SUNDRY NOTICES AND REPORTS ON WELLS

7. If Unit or CA/Agreement, Name and/or No.
Myers Langlie Mattix Unit8. Well Name and No.
#32

30-025-25736

**Myers Langlie Mattix Unit #32
OXY USA WTP Limited Partnership
December 14, 2006
Conditions of Approval**

OXY USA WTP LP
Myers Langlie Mattix Unit #32
API No. 30-025-25736

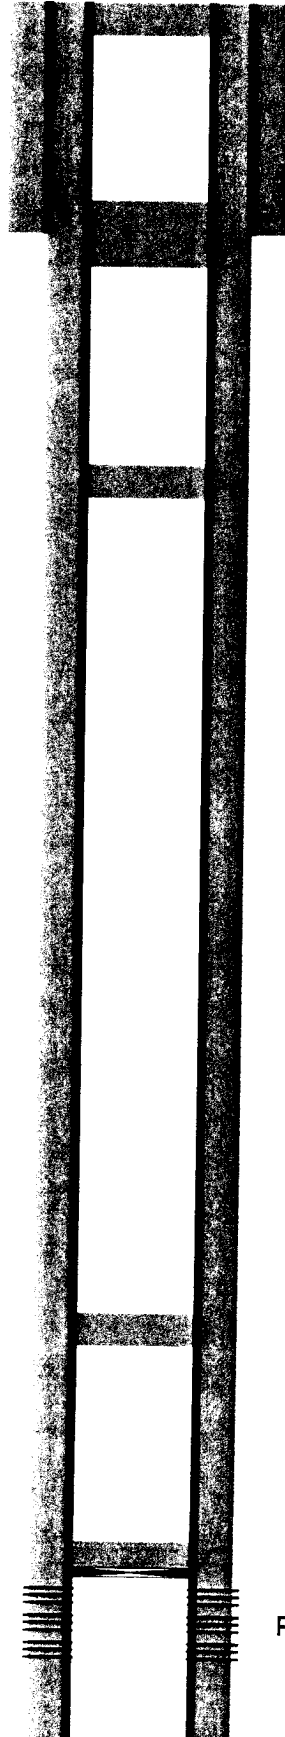
Step 2 Base of Salt plug (2710'-2810'). Tag plug.

Step 3 100'plug (minimum 25 sx) for Top of Salt (1220'-1320'). Tag plug.
